Mining Permit Application Amendment Copperwood Volume I

Project I.D.: 17C050

Copperwood Resources, Inc.
Gogebic County, Michigan

Re: Amendment to MP012012 for the Copperwood Mine

FIGURE 4-3
MINING PERMIT APPLICATION AMENDMENT
EXHAUST VENTILATION RAISE
CONCEPTUAL DESIGN
GOGEBIC COUNTY, MICHIGAN

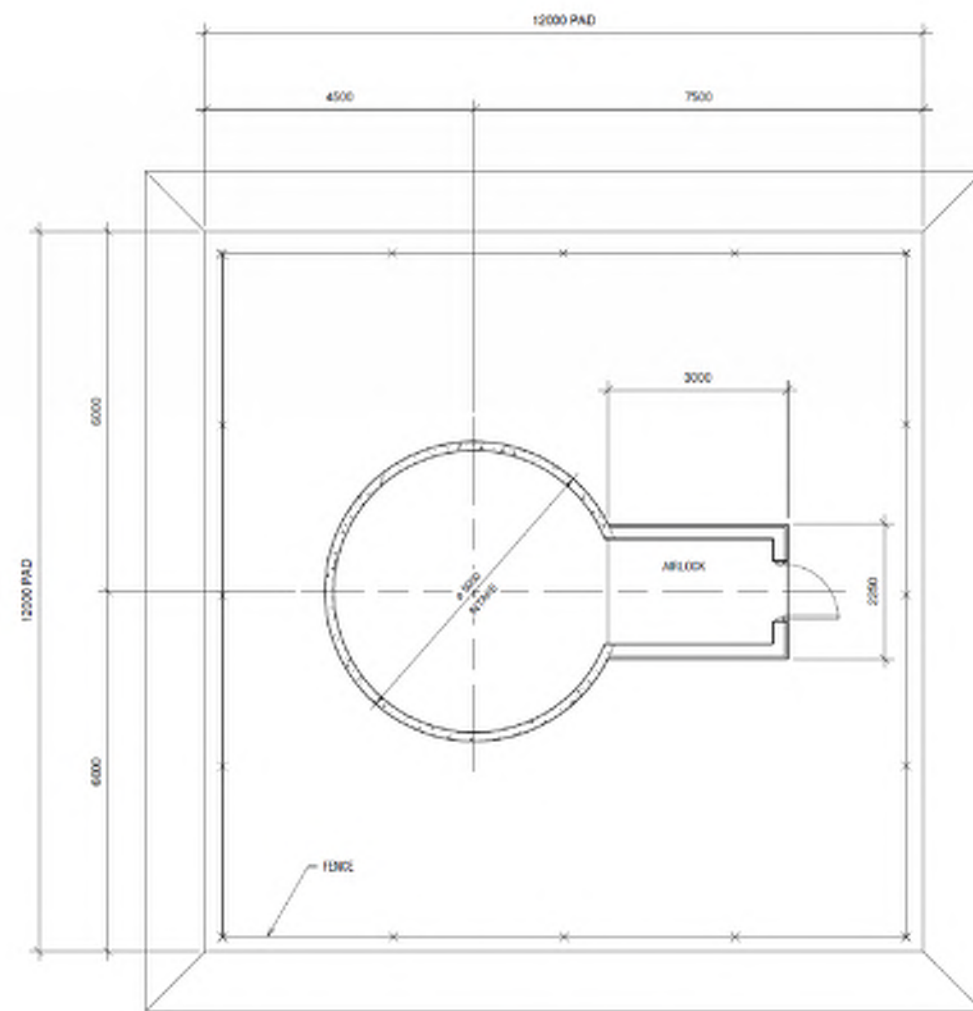
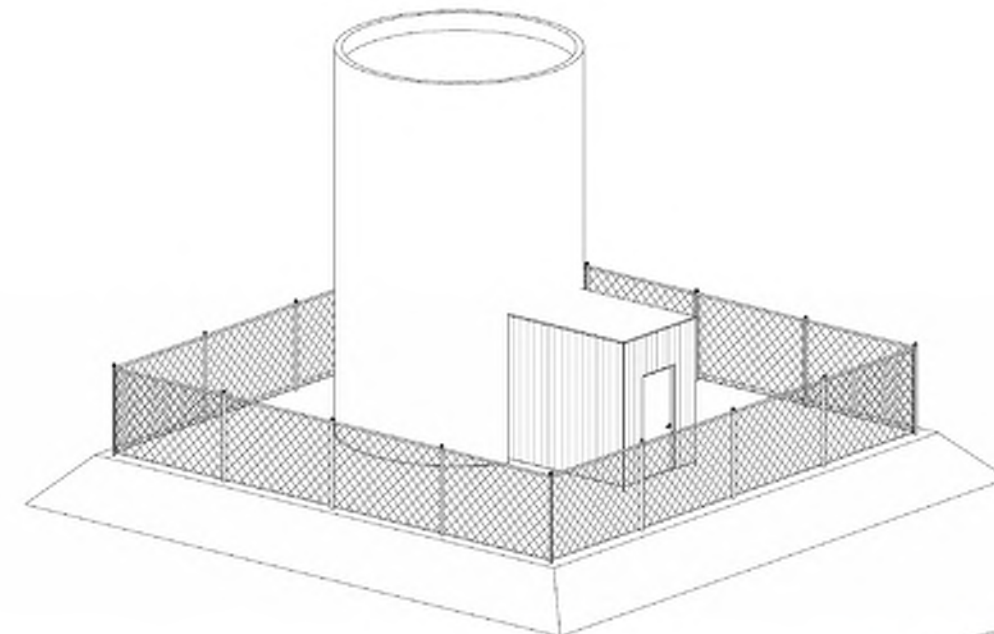
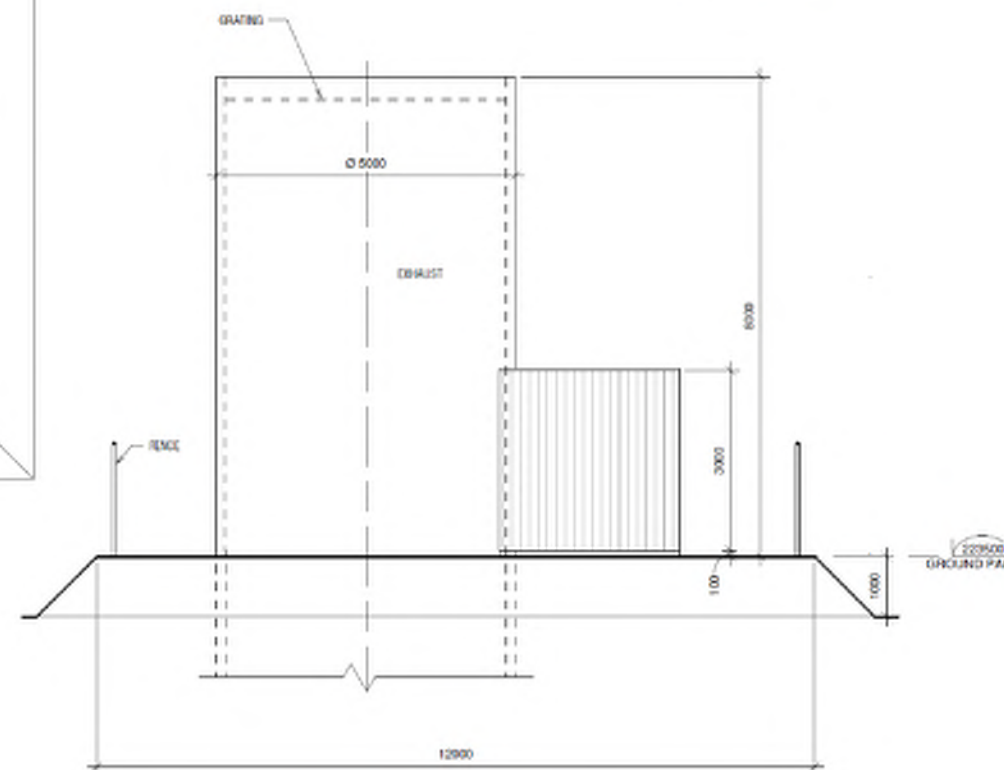
One intake ventilation and two exhaust ventilation raises will be required to support the underground mine ventilation requirements. The location of these three ventilation raises are shown on Figure 1-2. The intake raise is on uninhabited commercial forest property currently owned by the Hancock Natural Resource Group and will require some type of use agreement under mineral lease law. The exhaust raises are both on property owned by Copperwood.

FIGURE 4-12
MINING PERMIT APPLICATION AMENDMENT
MAIN VENTILATION LAYOUT
GOGEBIC COUNTY, MICHIGAN

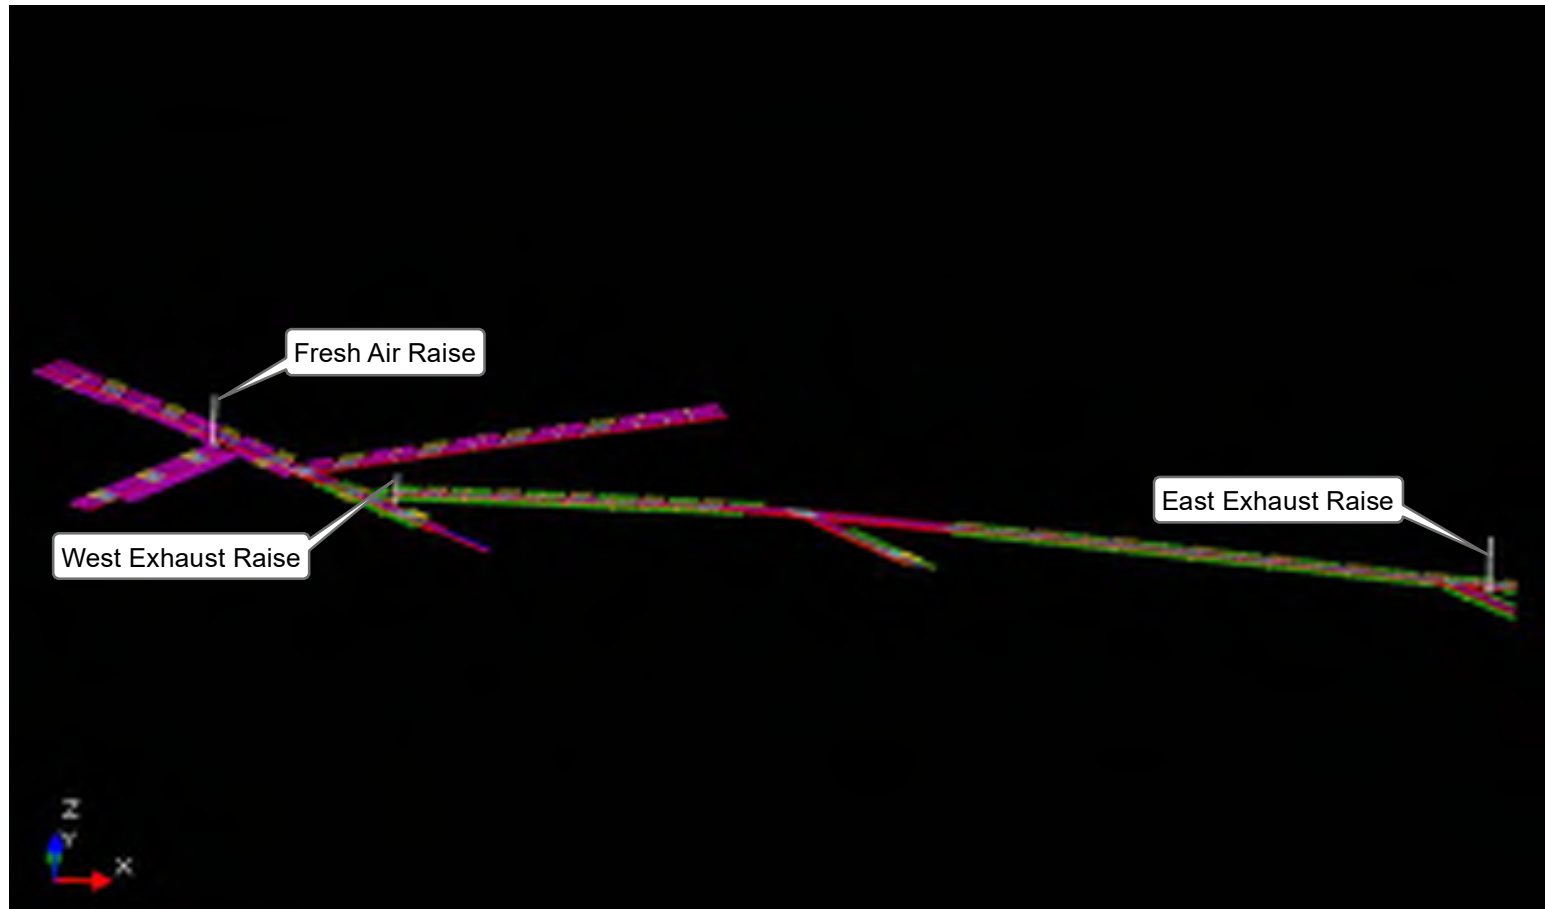
Ventilation requirements for the fully developed mine is estimated to be approximately 24,069 cubic meters per minute (850,000 cubic feet per minute). Intake air will be brought underground through one ventilation raise, where main fans will be installed. The fresh air will move through the main access drift to the working panel. Exhaust will be evacuated through the west exhaust ventilation raise, east exhaust ventilation raise, and at the mine access box-cut. The flow of each of the ventilation raises will vary over time. The main ventilation layout is depicted on Figure 4-12.

COPPERWOOD RESOURCES, INC.			
FIGURE 5-1 MINING PERMIT APPLICATION AMENDMENT ORE STOCKPILE CONCEPTUAL DESIGN GOGEBIC COUNTY, MICHIGAN			
Scale: NOT TO SCALE		Date: MARCH 2018	
Drafted by: DAT		Project: 17C050

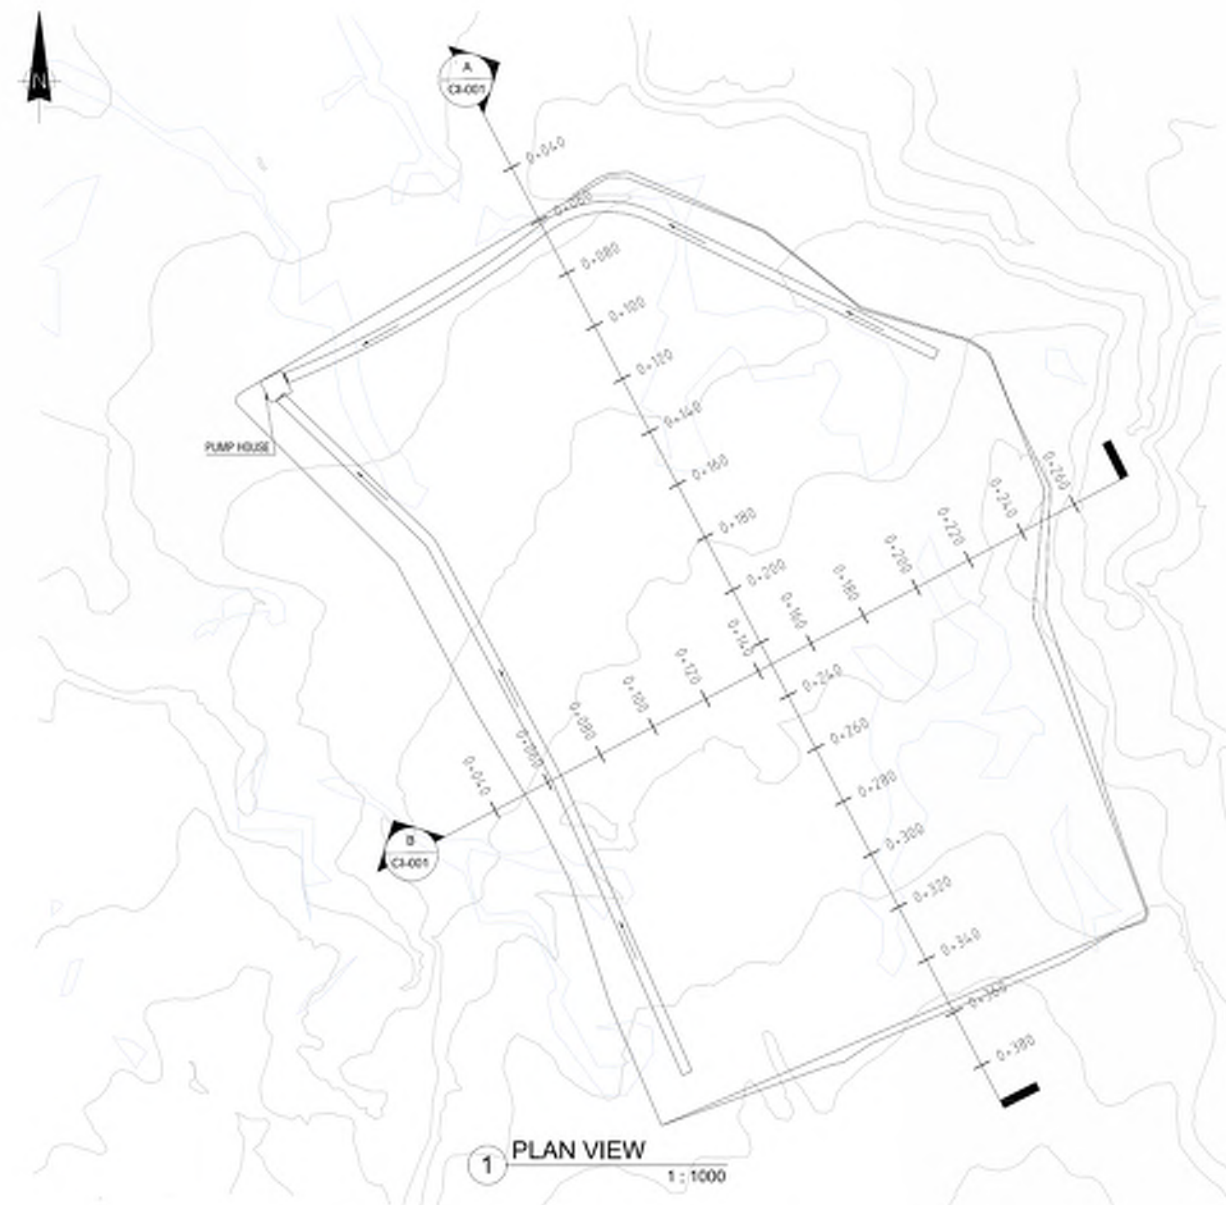
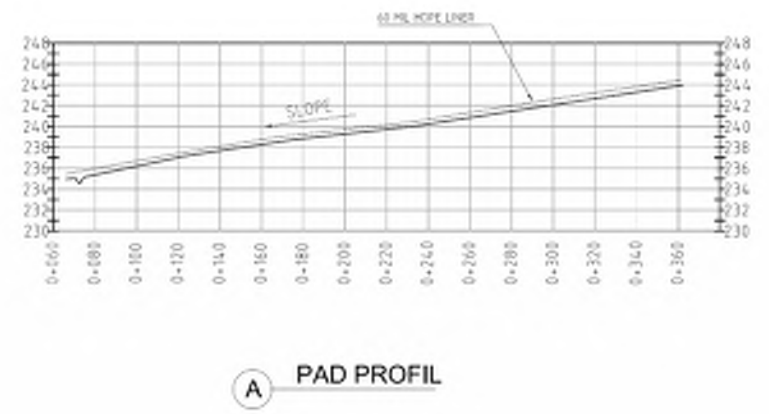
Ore will be managed in an outdoor stockpile. The location of the stockpile is shown on Figure 1-2. The purpose of the ore stockpile is to provide surge capacity between the underground mine and the process plant to facilitate continuous underground mine operation when ore production temporarily exceeds the process plant capacity. The ore stockpile has been designed to temporarily store up to 620,000 tonnes of ore, with a total maximum height of 15 m. The base of the stockpile will be constructed using clay till excavated from the development of the box-cut. The compacted clay till base will be covered with a 60-mil thick high-density polyethylene geomembrane liner. The conceptual design of the ore stockpile is shown on Figure 5-1. Contact water collected on the composite liner will be managed through the use of internal ditches and a pumping station as shown on Figures 4-5 and 5-1. Contact water from the ore stockpile will be routed to an event pond, prior to being pumped to the TDF.

FIGURE 6-1
MINING PERMIT APPLICATION AMENDMENT
GROUNDWATER MONITORING LOCATIONS
GOGEBIC COUNTY, MICHIGAN

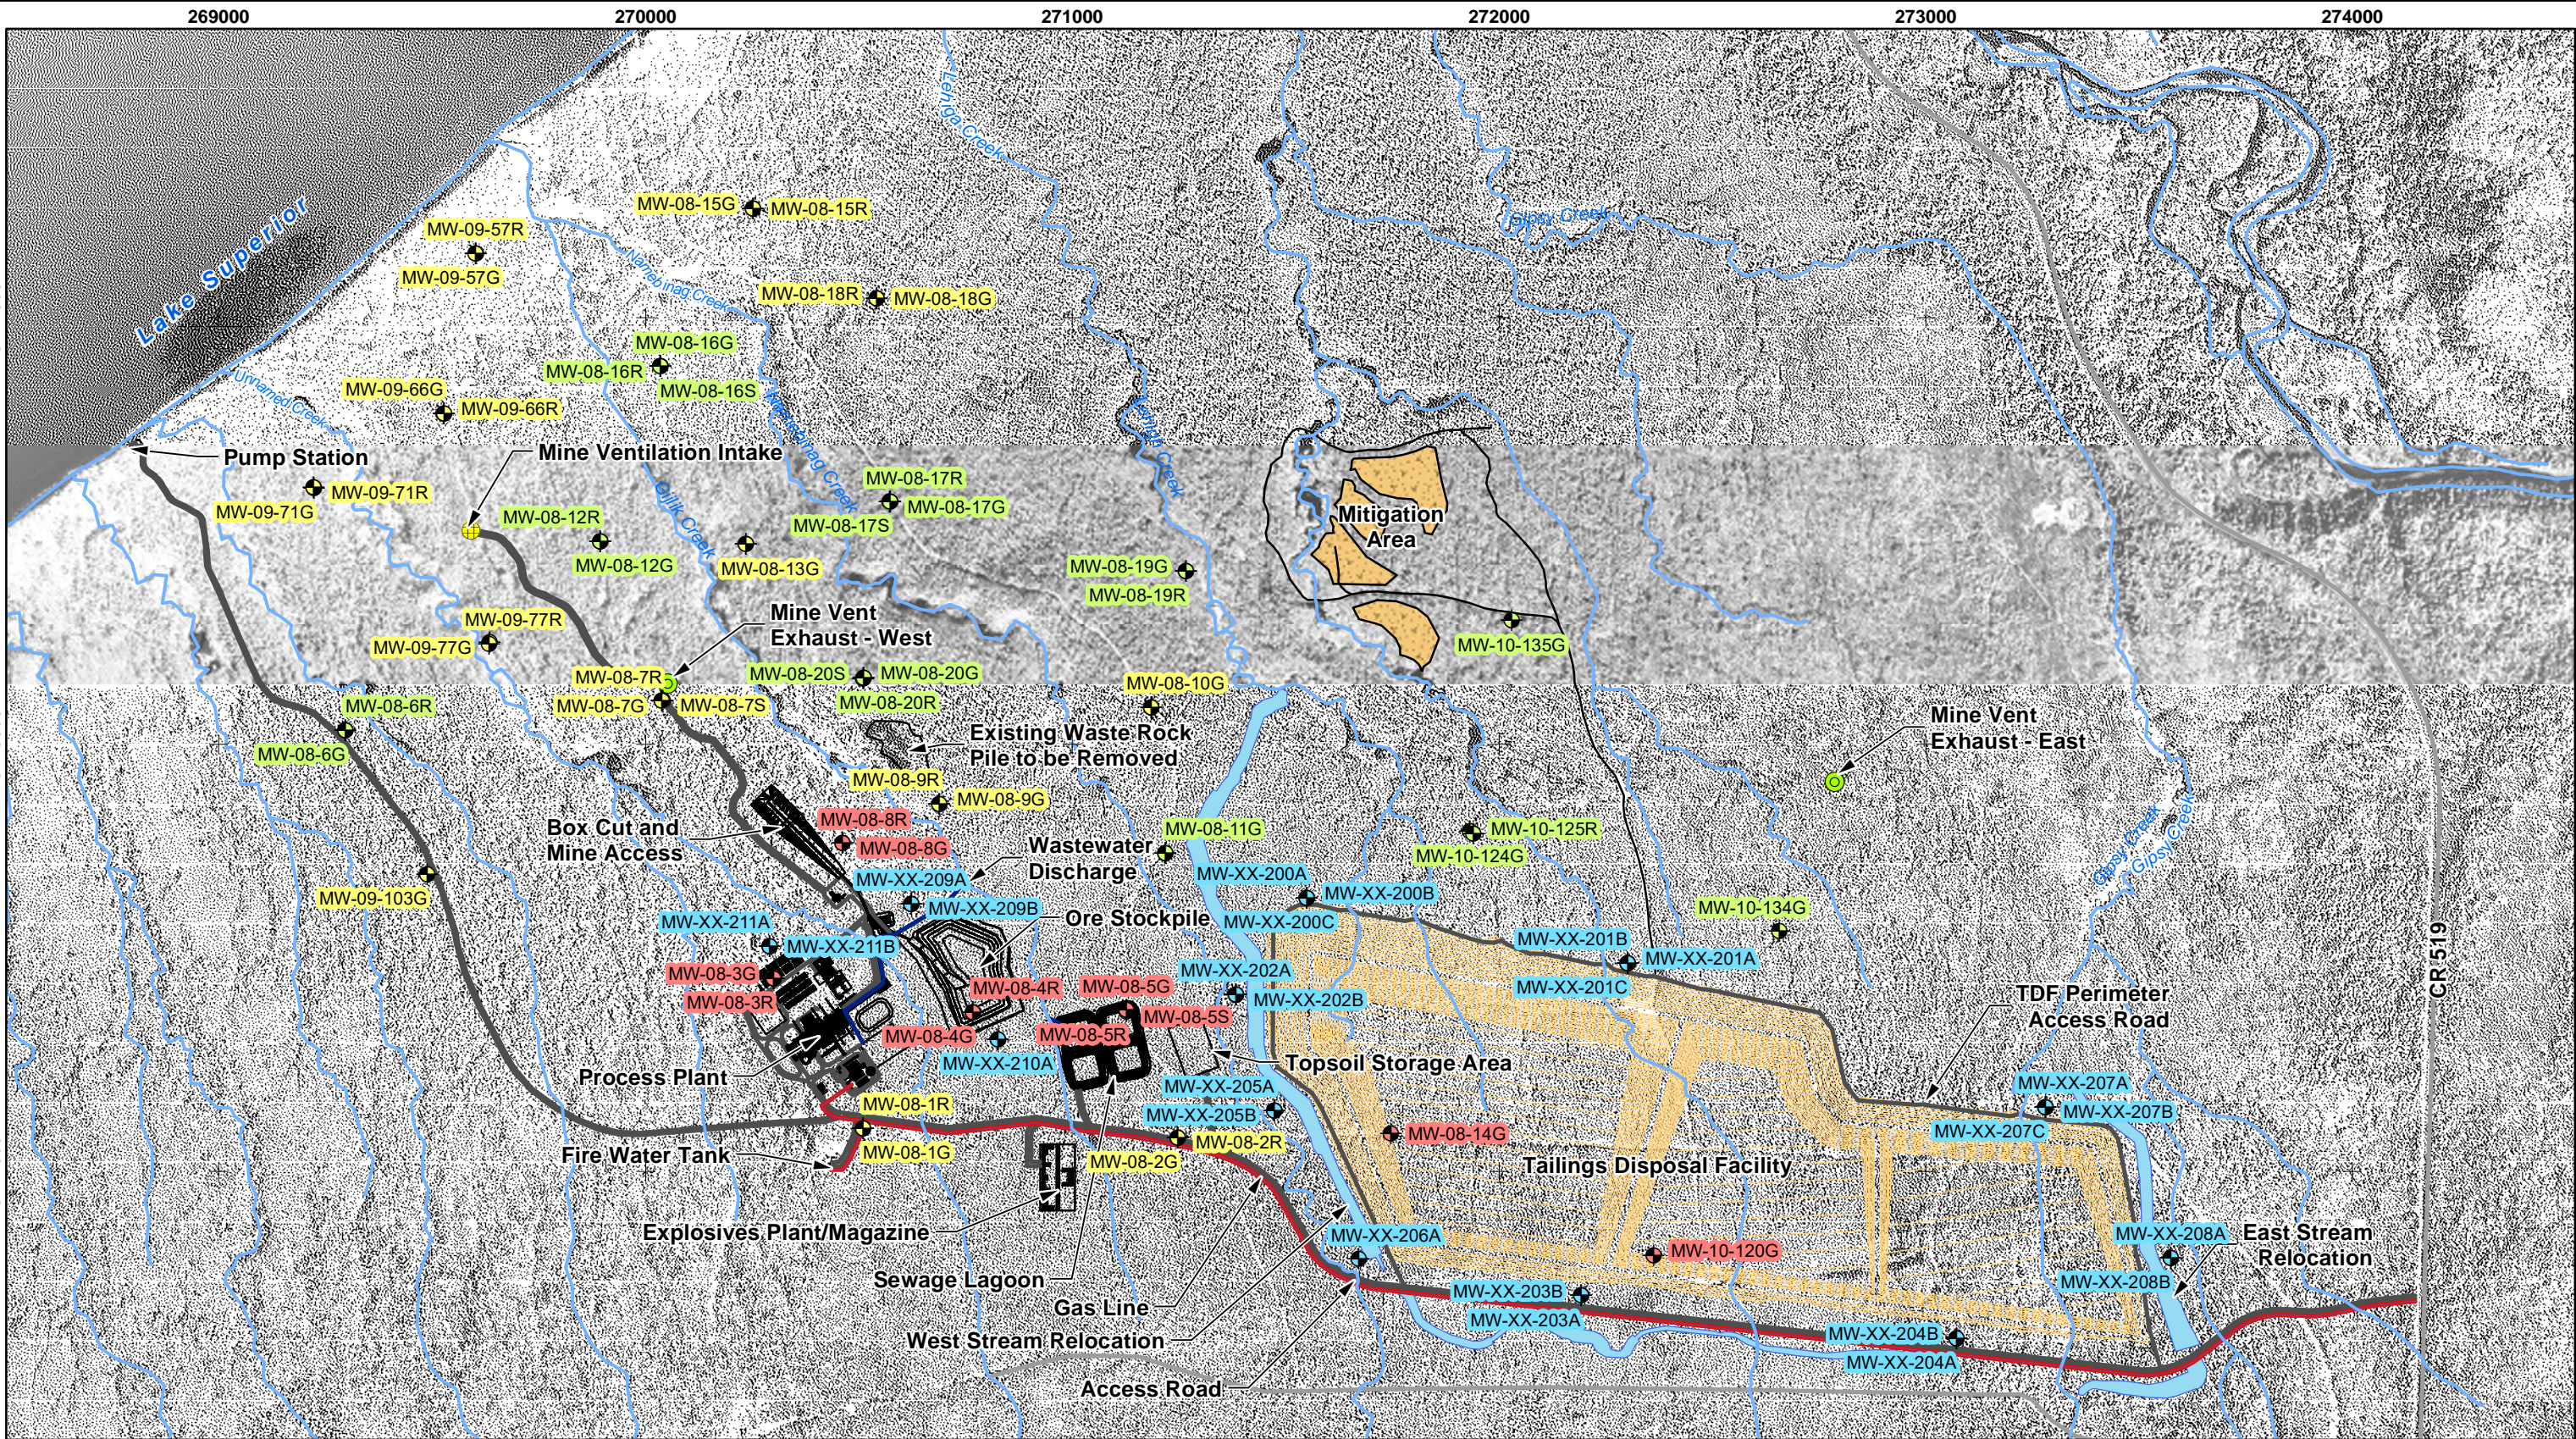
The groundwater and surface water monitoring plan described in the MPA will continue to be followed during development, operations, and post mining with one exception. Changes to the monitoring well network are required due to the revised Project site layout. Existing well nests at MW-08-3 and MW-08-5 are within the process plant and sewage lagoon layout, respectively, and are likely to be abandoned during construction. The monitoring wells proposed in the MPA (MW-XX-200 through MW-XX-208) for the monitoring of the TDF remain valid with minor adjustments to the proposed locations being warranted due to the revised Project site layout. Table 6-1 presents a summary of the revised proposed locations.

Monitoring wells MW-XX-209A and MW-XX-209B will be moved to the south, to be located immediately downgradient of the ore stockpile. Monitoring wells MW-XX-210A and MW-XX-210B will be moved to the southwest, to be located immediately upgradient of the ore stockpile. The revised proposed coordinates for these wells are provided in Table 6-1.

One new monitoring well nest consisting of MW-XX-211A and MW-XX-211B, is proposed to be added downgradient of the process plant area. MW-XX-211A will be a shallow well screen across the water table. MW-XX-211B will be a deeper well screen at the base of the overburden. This well nest will be monitored for water quality and water levels consistent with the other previously proposed monitoring wells. The revised proposed coordinates for these wells are provided in Table 6-1.

The location of monitoring wells, and an indication of the type of monitoring that will be conducted at each location, is shown on Figure 6-1. Monitoring parameters, methods, and frequency described in the MPA remains valid.
